工程指示 / 要求簡箋 ENGINEER INSTRUCTIONS (E.I.)

| 工程指示編號: | EI- 4790D | 修改版本: | D |
| 工程編號: | J 853 | 工程名稱: | 大窩坪 (延坪道) |
| 工程項目: | T3 幕牆單元件生產 (大貨) (修訂D:修改Z字碼設計及修改分格呎吋) | 日期: | 29/07/2022 |

| 名稱 | 多點鎖放樣圖 | 制圖 | 付吉寧 | 2022.05.20 | 修改 | A | | |

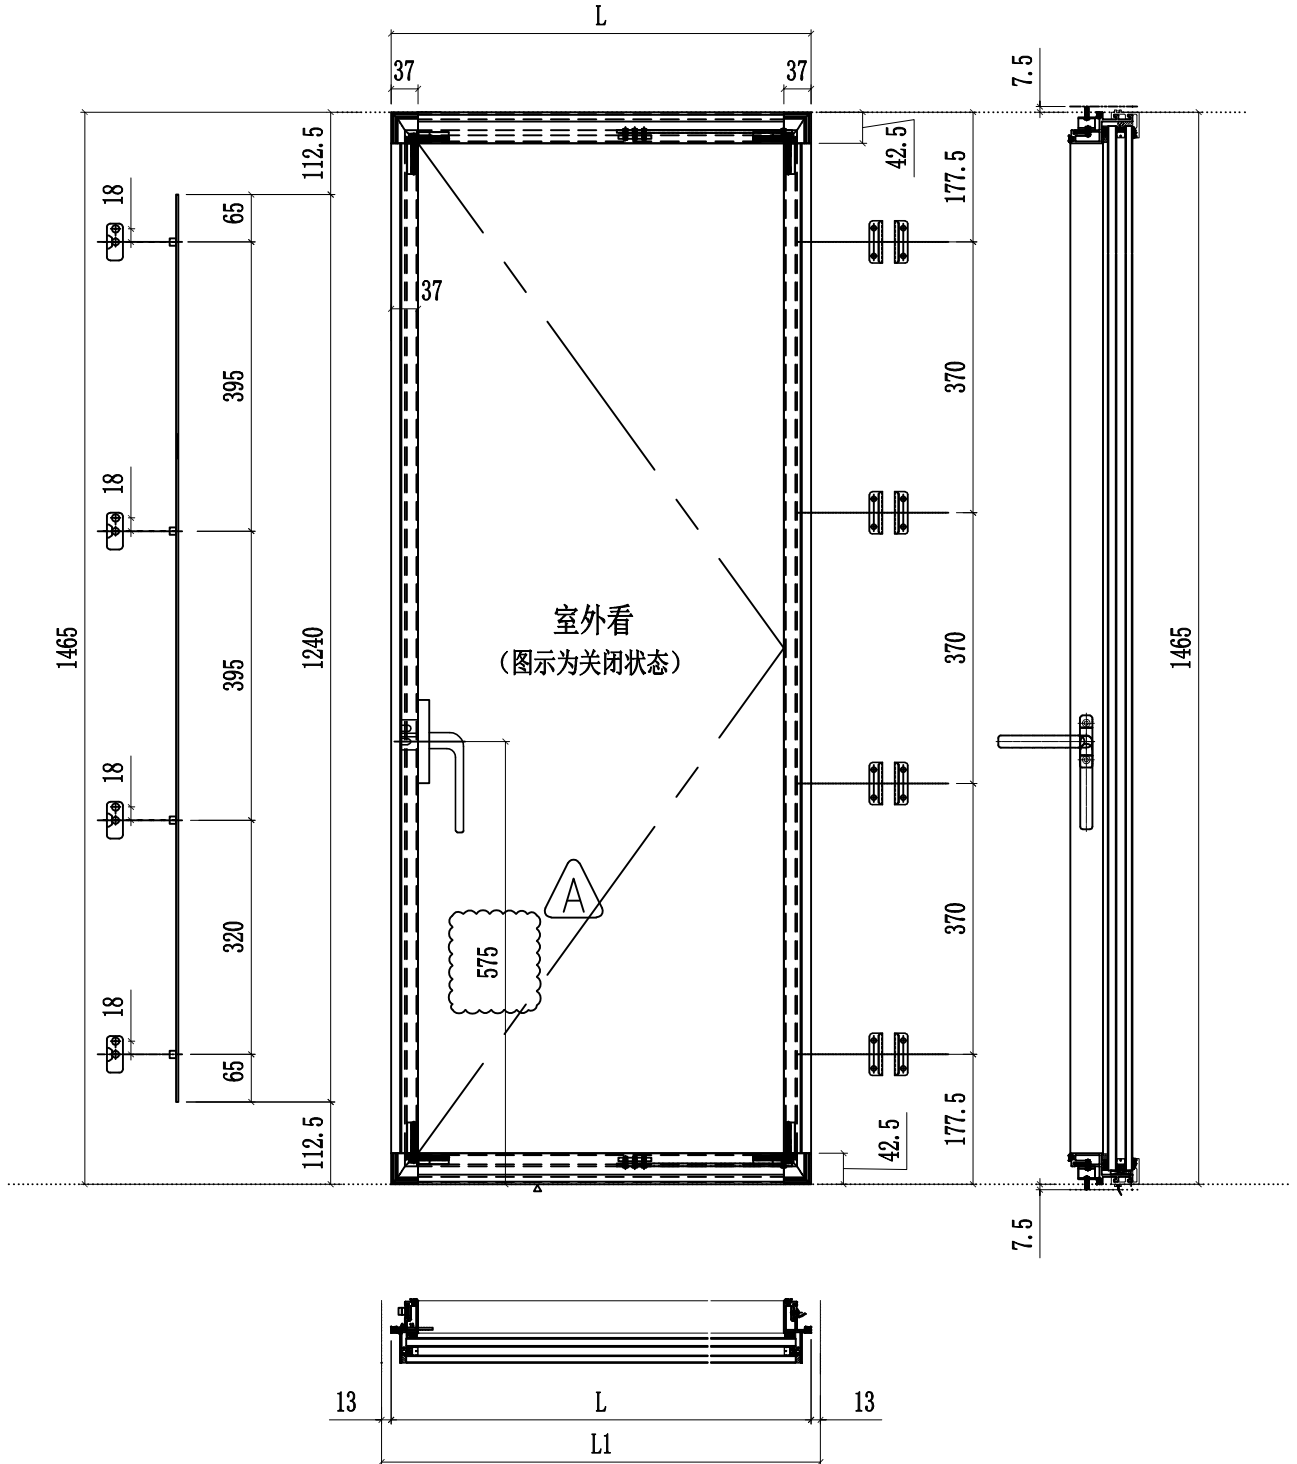
雲線處依據EI-4891 修改手柄高度

| 名稱 | 多點鎖放樣圖 | 制圖 | 付吉寧 | 2022.05.20 | 修改 | A | |

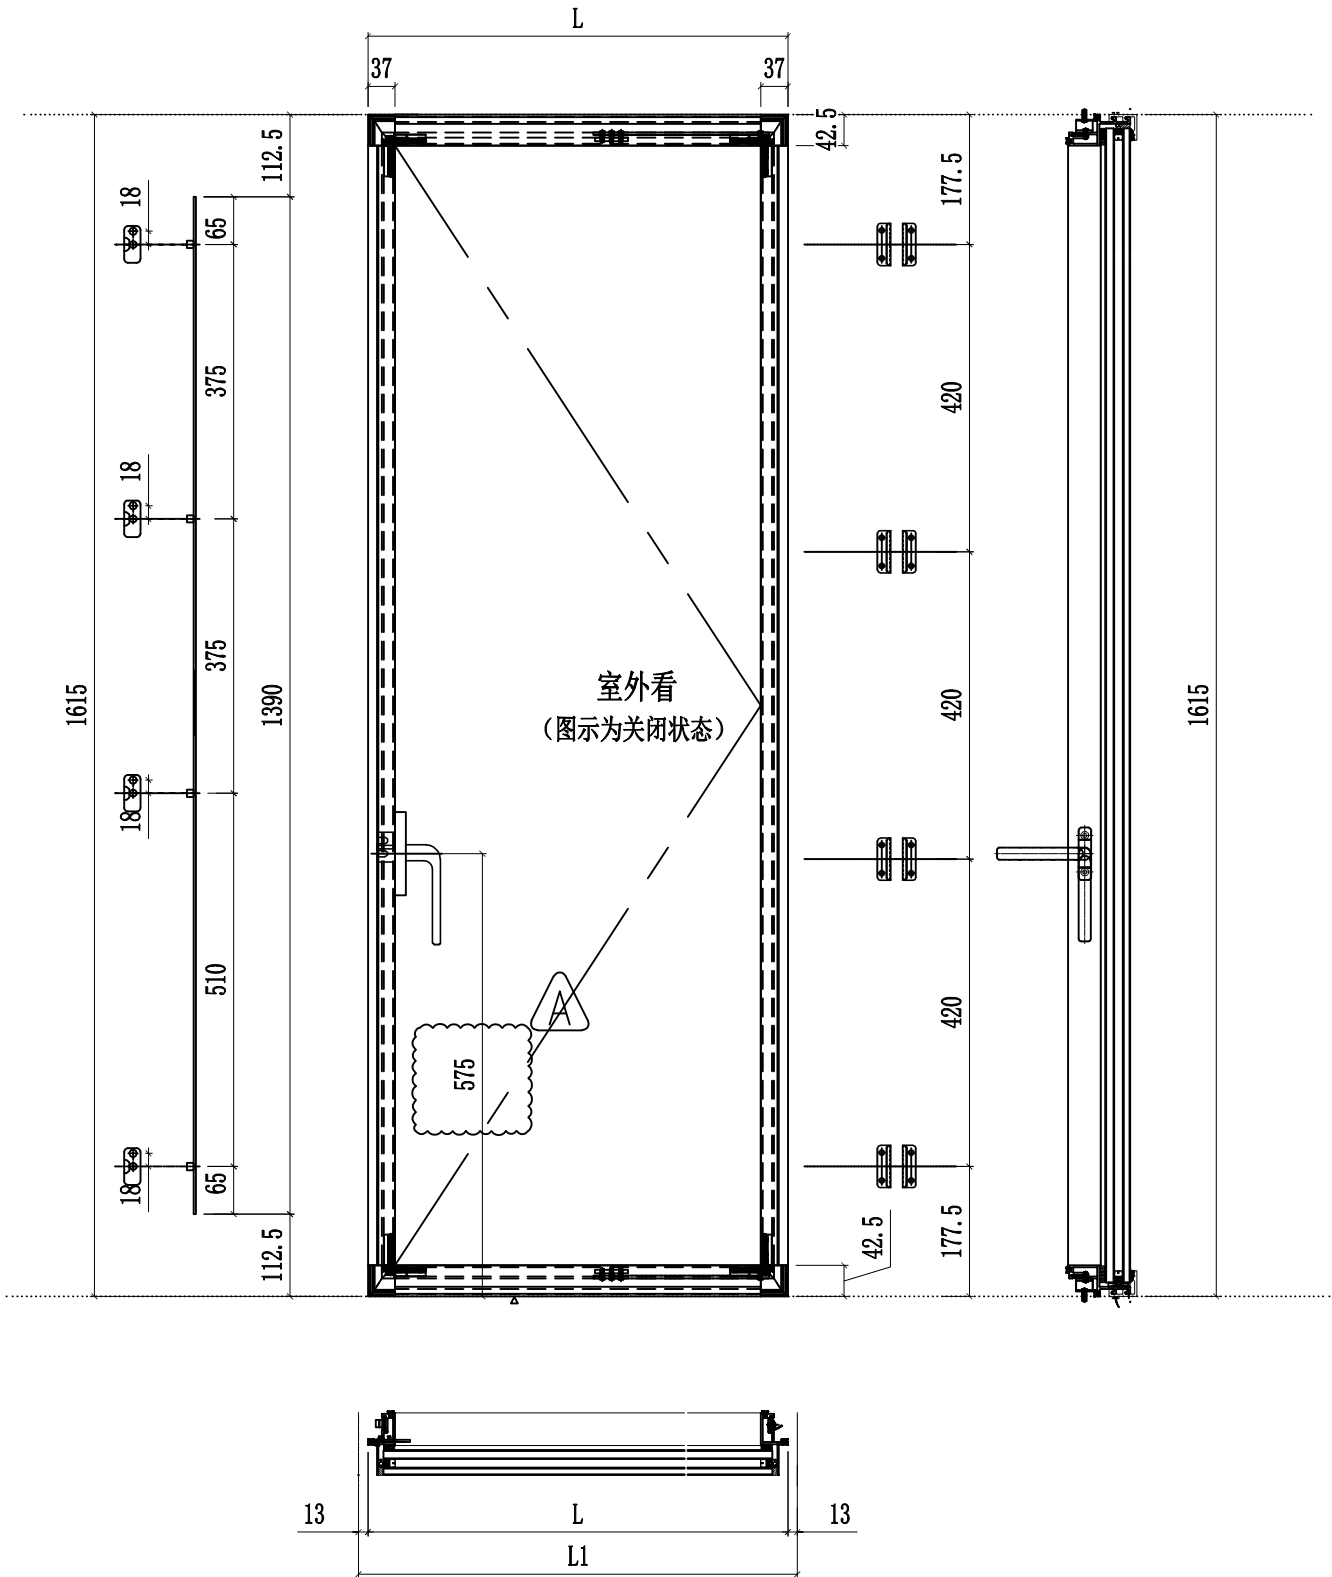
雲線處依據EI-4891 修改手柄高度

| 名稱 | 多點鎖放樣圖 | 制圖 | 付吉寧 | 2022.05.20 | 修改 | A | | |

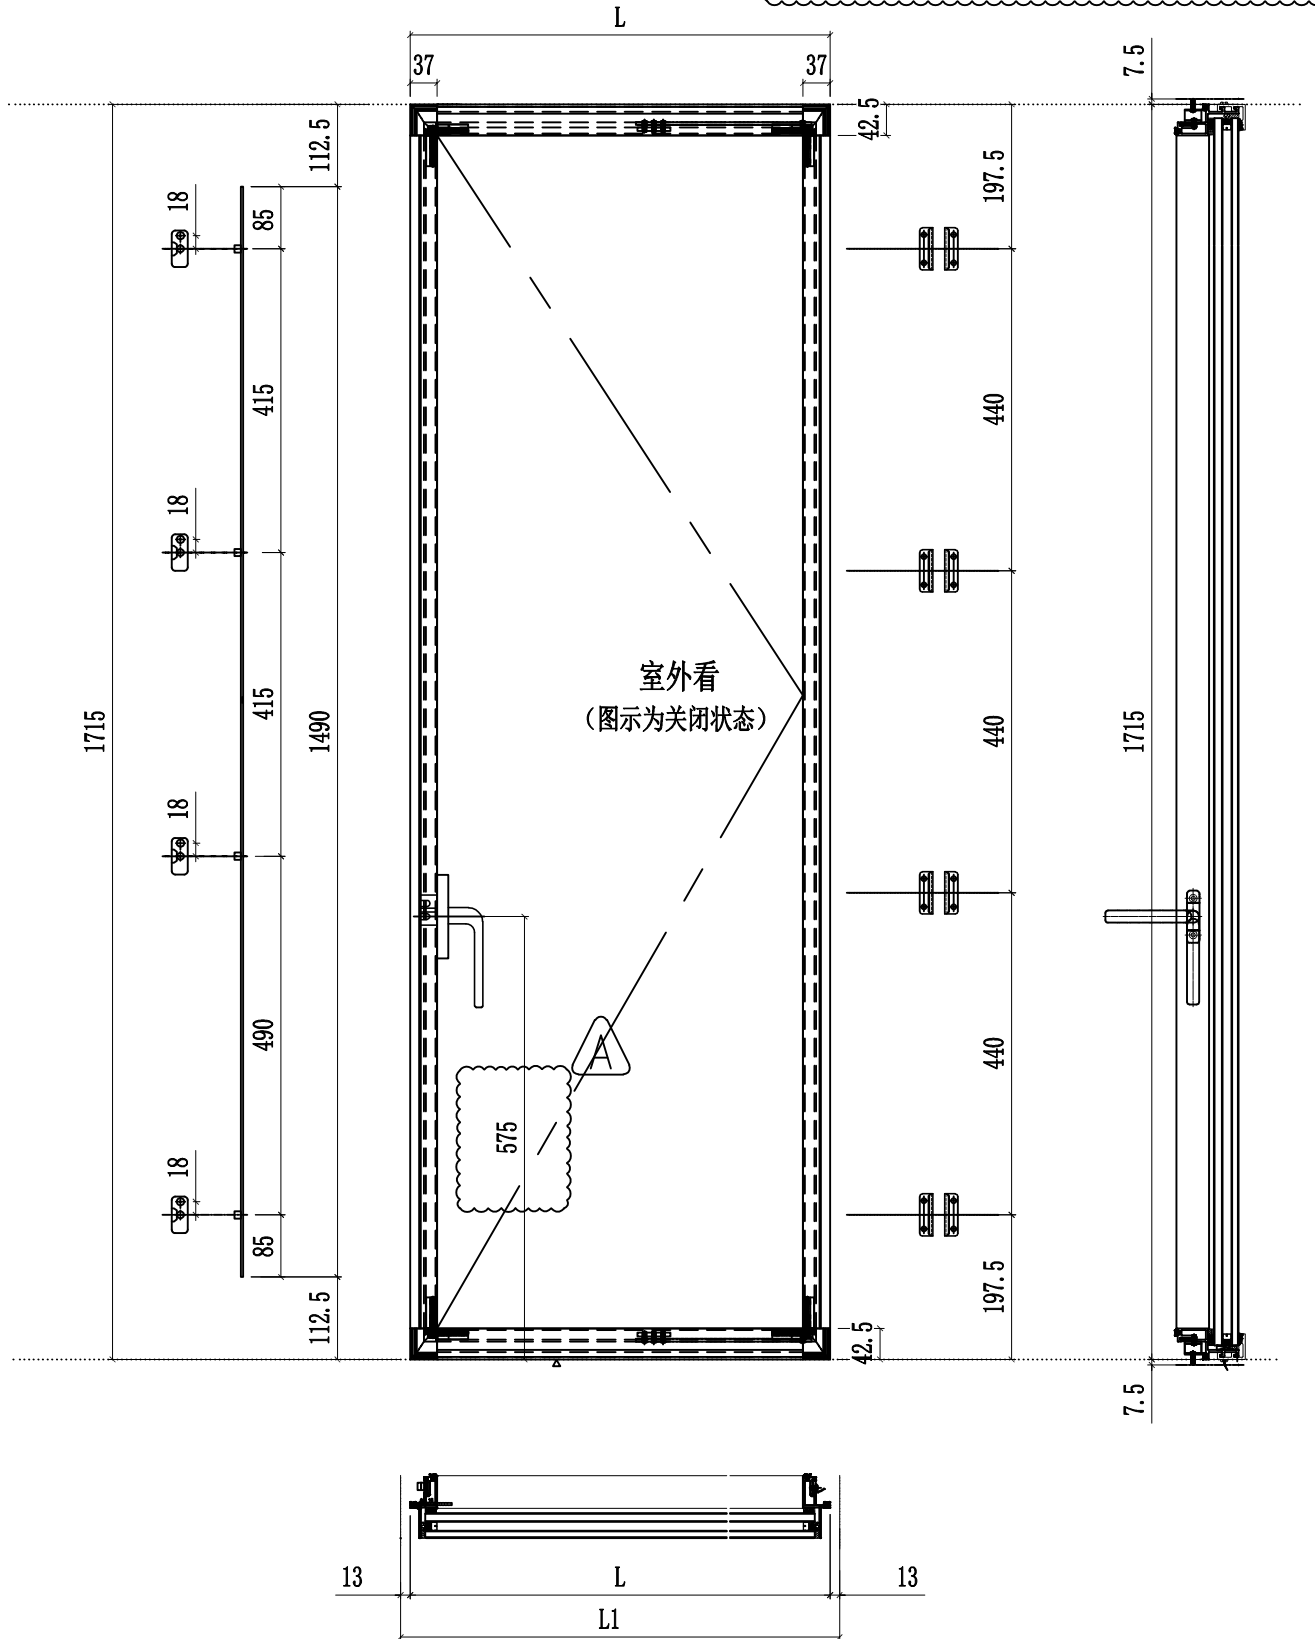
雲線處依據EI-4891 修改手柄高度
